Mona Vale Road East upgrade – Manor Road, Ingleside to Foley Street, Mona Vale

Submissions Report

December 2015

Prepared by SMEC Australia Pty Ltd
RMS 15.647

Figure 3-1 Project Layout, Receivers and NCAs – East (source Pacific Environment, November 2015)

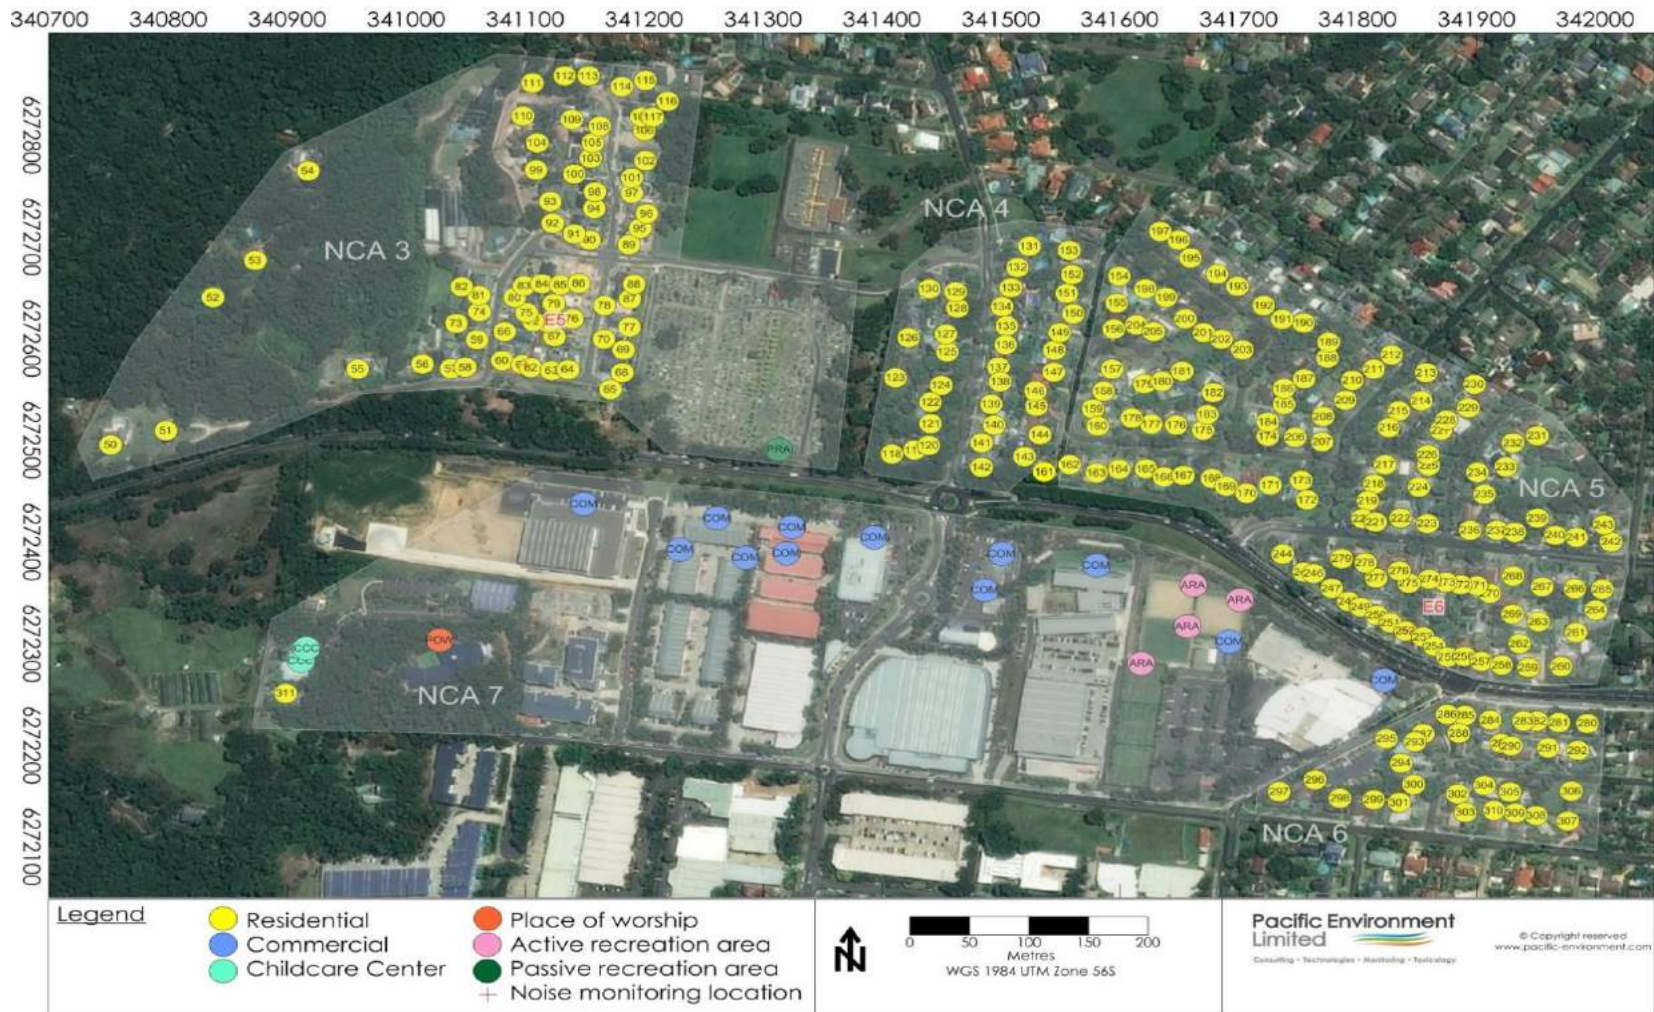
- 2) Existing noise from heavy vehicles using compression brakes to maintain a slow speed as they descend Mona Vale Road into Mona Vale is of concern to some residents. The proposal to change the posted speed for heavy vehicles to 60 km/h on that stretch of Mona Vale Road will require greater use of compression brakes to stay within the speed limit, thereby increasing the frequency of compression brake noise. Noise from compression brakes are worse in the evening and night time (sleep disturbance) when other background noise is low. Would like to see a sign advising that compression brakes are prohibited in this area and retain the sign advising the use of low gears.

- 3) With the proposed design changes, noise levels between Walana Crescent and Samuel Street are likely to reduce from those predicted in the REF (refer Appendix B). Noise mitigation is therefore not warranted at this location. However a further noise investigation would be completed as part of detailed design and mitigation measures confirmed at that stage.
- 4) The Noise and Vibration Management Plan to be included in CEMP for the proposal will address practical measures to accommodate construction around the cemetery. Roads and Maritime will work with Council on an appropriate approach.

Figure 3-1 provides noise catchment areas for the proposal (as shown in the REF). The revised assessment shows that with the change in the road alignment, there is a reduction in the number of receivers exceeding the noise criteria in noise catchment areas (NCA) 4 and 5. The total number of receivers exceeding the criteria is predicted to reduce by 11 for the Mona Vale Road East only scenario and by seven receivers for the Mona Vale Road East plus West scenario when compared with the previous design displayed in the REF. Fractional increases of 0.1- 0.4 dB(A) were reported at 11 receivers where changes in road geometry increased noise exposure. These increases did not result in any additional receivers requiring mitigation treatments.

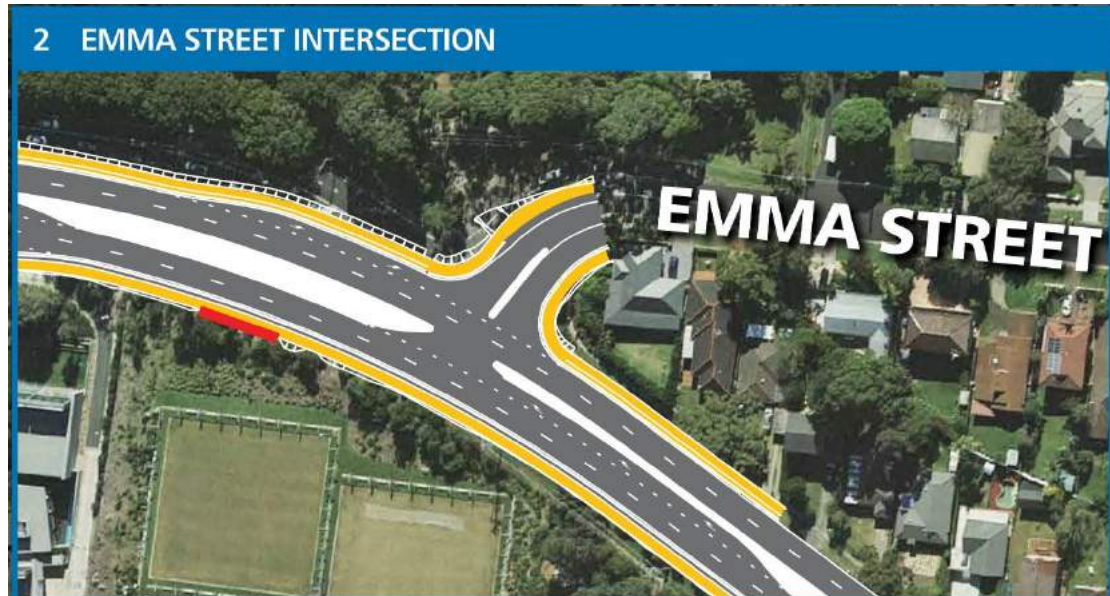
The current Mona Vale Road and Emma Street intersection arrangement allows all turning movements in and out of Emma Street. The proposal, as described in section 3 of the REF, includes treatments which will change the Emma Street intersection to left in and left out only. With the removal of right turn movements into and out of Emma Street, it was proposed that a number of alternate routes would need to be utilised, including Samuel Street, Bungan Street, Oliver Way, Maxwell Street, Parkland Road and Foley Street.

- 2) With the change in access arrangements for Emma Street there is concern that there will be increased traffic on the streets surrounding the Mona Vale Public School (Waratah Street, Wangara Street, Oliver Way and Bungan Street) where currently the traffic around the school is predominantly associated with local residents and with school drop offs and pick-ups. There is concern for school children safety. In addition the school bus currently travels Waratah Street to Maxwell Street and on to Emma Street in order to access onto Mona Vale Road. This route will need to be altered leading to additional travel time for the bus and exacerbating the anticipated congestion on the alternative routes.

- 4) Some respondents are concerned about the potential increase in traffic on Whitney Street as a result of the proposed change to turning movements at Emma Street (left in and left out only). It is considered likely that traffic will use Whitney Street as a shortcut between Parkland Road and Samuel Street causing congestion, safety concerns for pedestrians, increased road traffic noise and difficulties accessing properties. Some respondents requested that Whitney Street should be closed (by creating a cul-de-sac or similar) to through traffic to prevent this from occurring.

In response to submissions and community concern, Roads and Maritime re-investigated intersection treatment options in order to provide a suitable right turn movements in and out of Emma Street. As a result a channelised right turn treatment is now proposed as a design refinement to the proposal, allowing the full range of turning movements at this intersection.

The revised layout of the Mona Vale Road and Emma Street intersection is shown in **Figure 4-2** and extracted below.

The revised intersection layout includes a channelised right turn layout with a sheltered right turn bay in the median of Mona Vale Road for right turning vehicles turning into Emma Street. The revised intersection layout retains all existing traffic movements and ensures that access is retained for local residents seeking to continue utilising the intersection.

Figure 4-3 Truck arrester bed profile

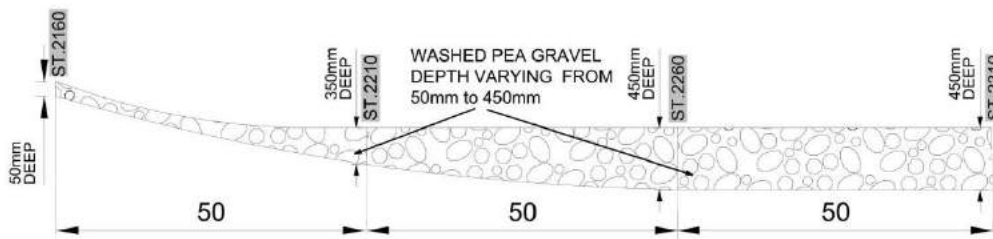
The original proposal presented in the REF, includes provision of a truck arrester bed next to the eastbound lane approaching Walana Crescent, near the bottom of the steep descent. Alternative locations were investigated by Roads and Maritime in response to community feedback. The revised location for the truck arrester bed is about 300 metres further west up Mona Vale Road next to the eastbound lane (refer to **Figure 4-1**). This moves the proposed truck arrester bed away from residential properties on Walana Crescent / Wallaby Circuit and the Mona Vale General Cemetery.

- 2) In response to submissions received regarding the location of the truck arrester bed, Roads and Maritime has relocated the truck arrester bed to a suitable site further west and away from the Mona Vale Public Cemetery. This proposed design change is considered to address Pittwater Council's concern regarding the future expansion of the cemetery. Roads and Maritime will continue to engage with Council as the project progresses to detailed design so the design is aligned where possible with any relevant Council plans for the area.

The purpose of the arrester bed is to provide a safe 'escape route' for heavy vehicles with braking problems. The heavy vehicle is safely decelerated and stopped by the drag caused by the vehicle as it sinks into the bed material. The proposed arrester bed would be five metres wide and about 150 metres long. The bed material would be washed pea gravel to a depth varying between 50 millimetres and 450 millimetres. A 4.5 metre wide shoulder would be constructed adjacent to the arrester bed to facilitate maintenance. **Figure 4-1** shows the truck arrester bed as part of the broader proposal, while **Figure 4-3** shows the proposed arrester bed profile.
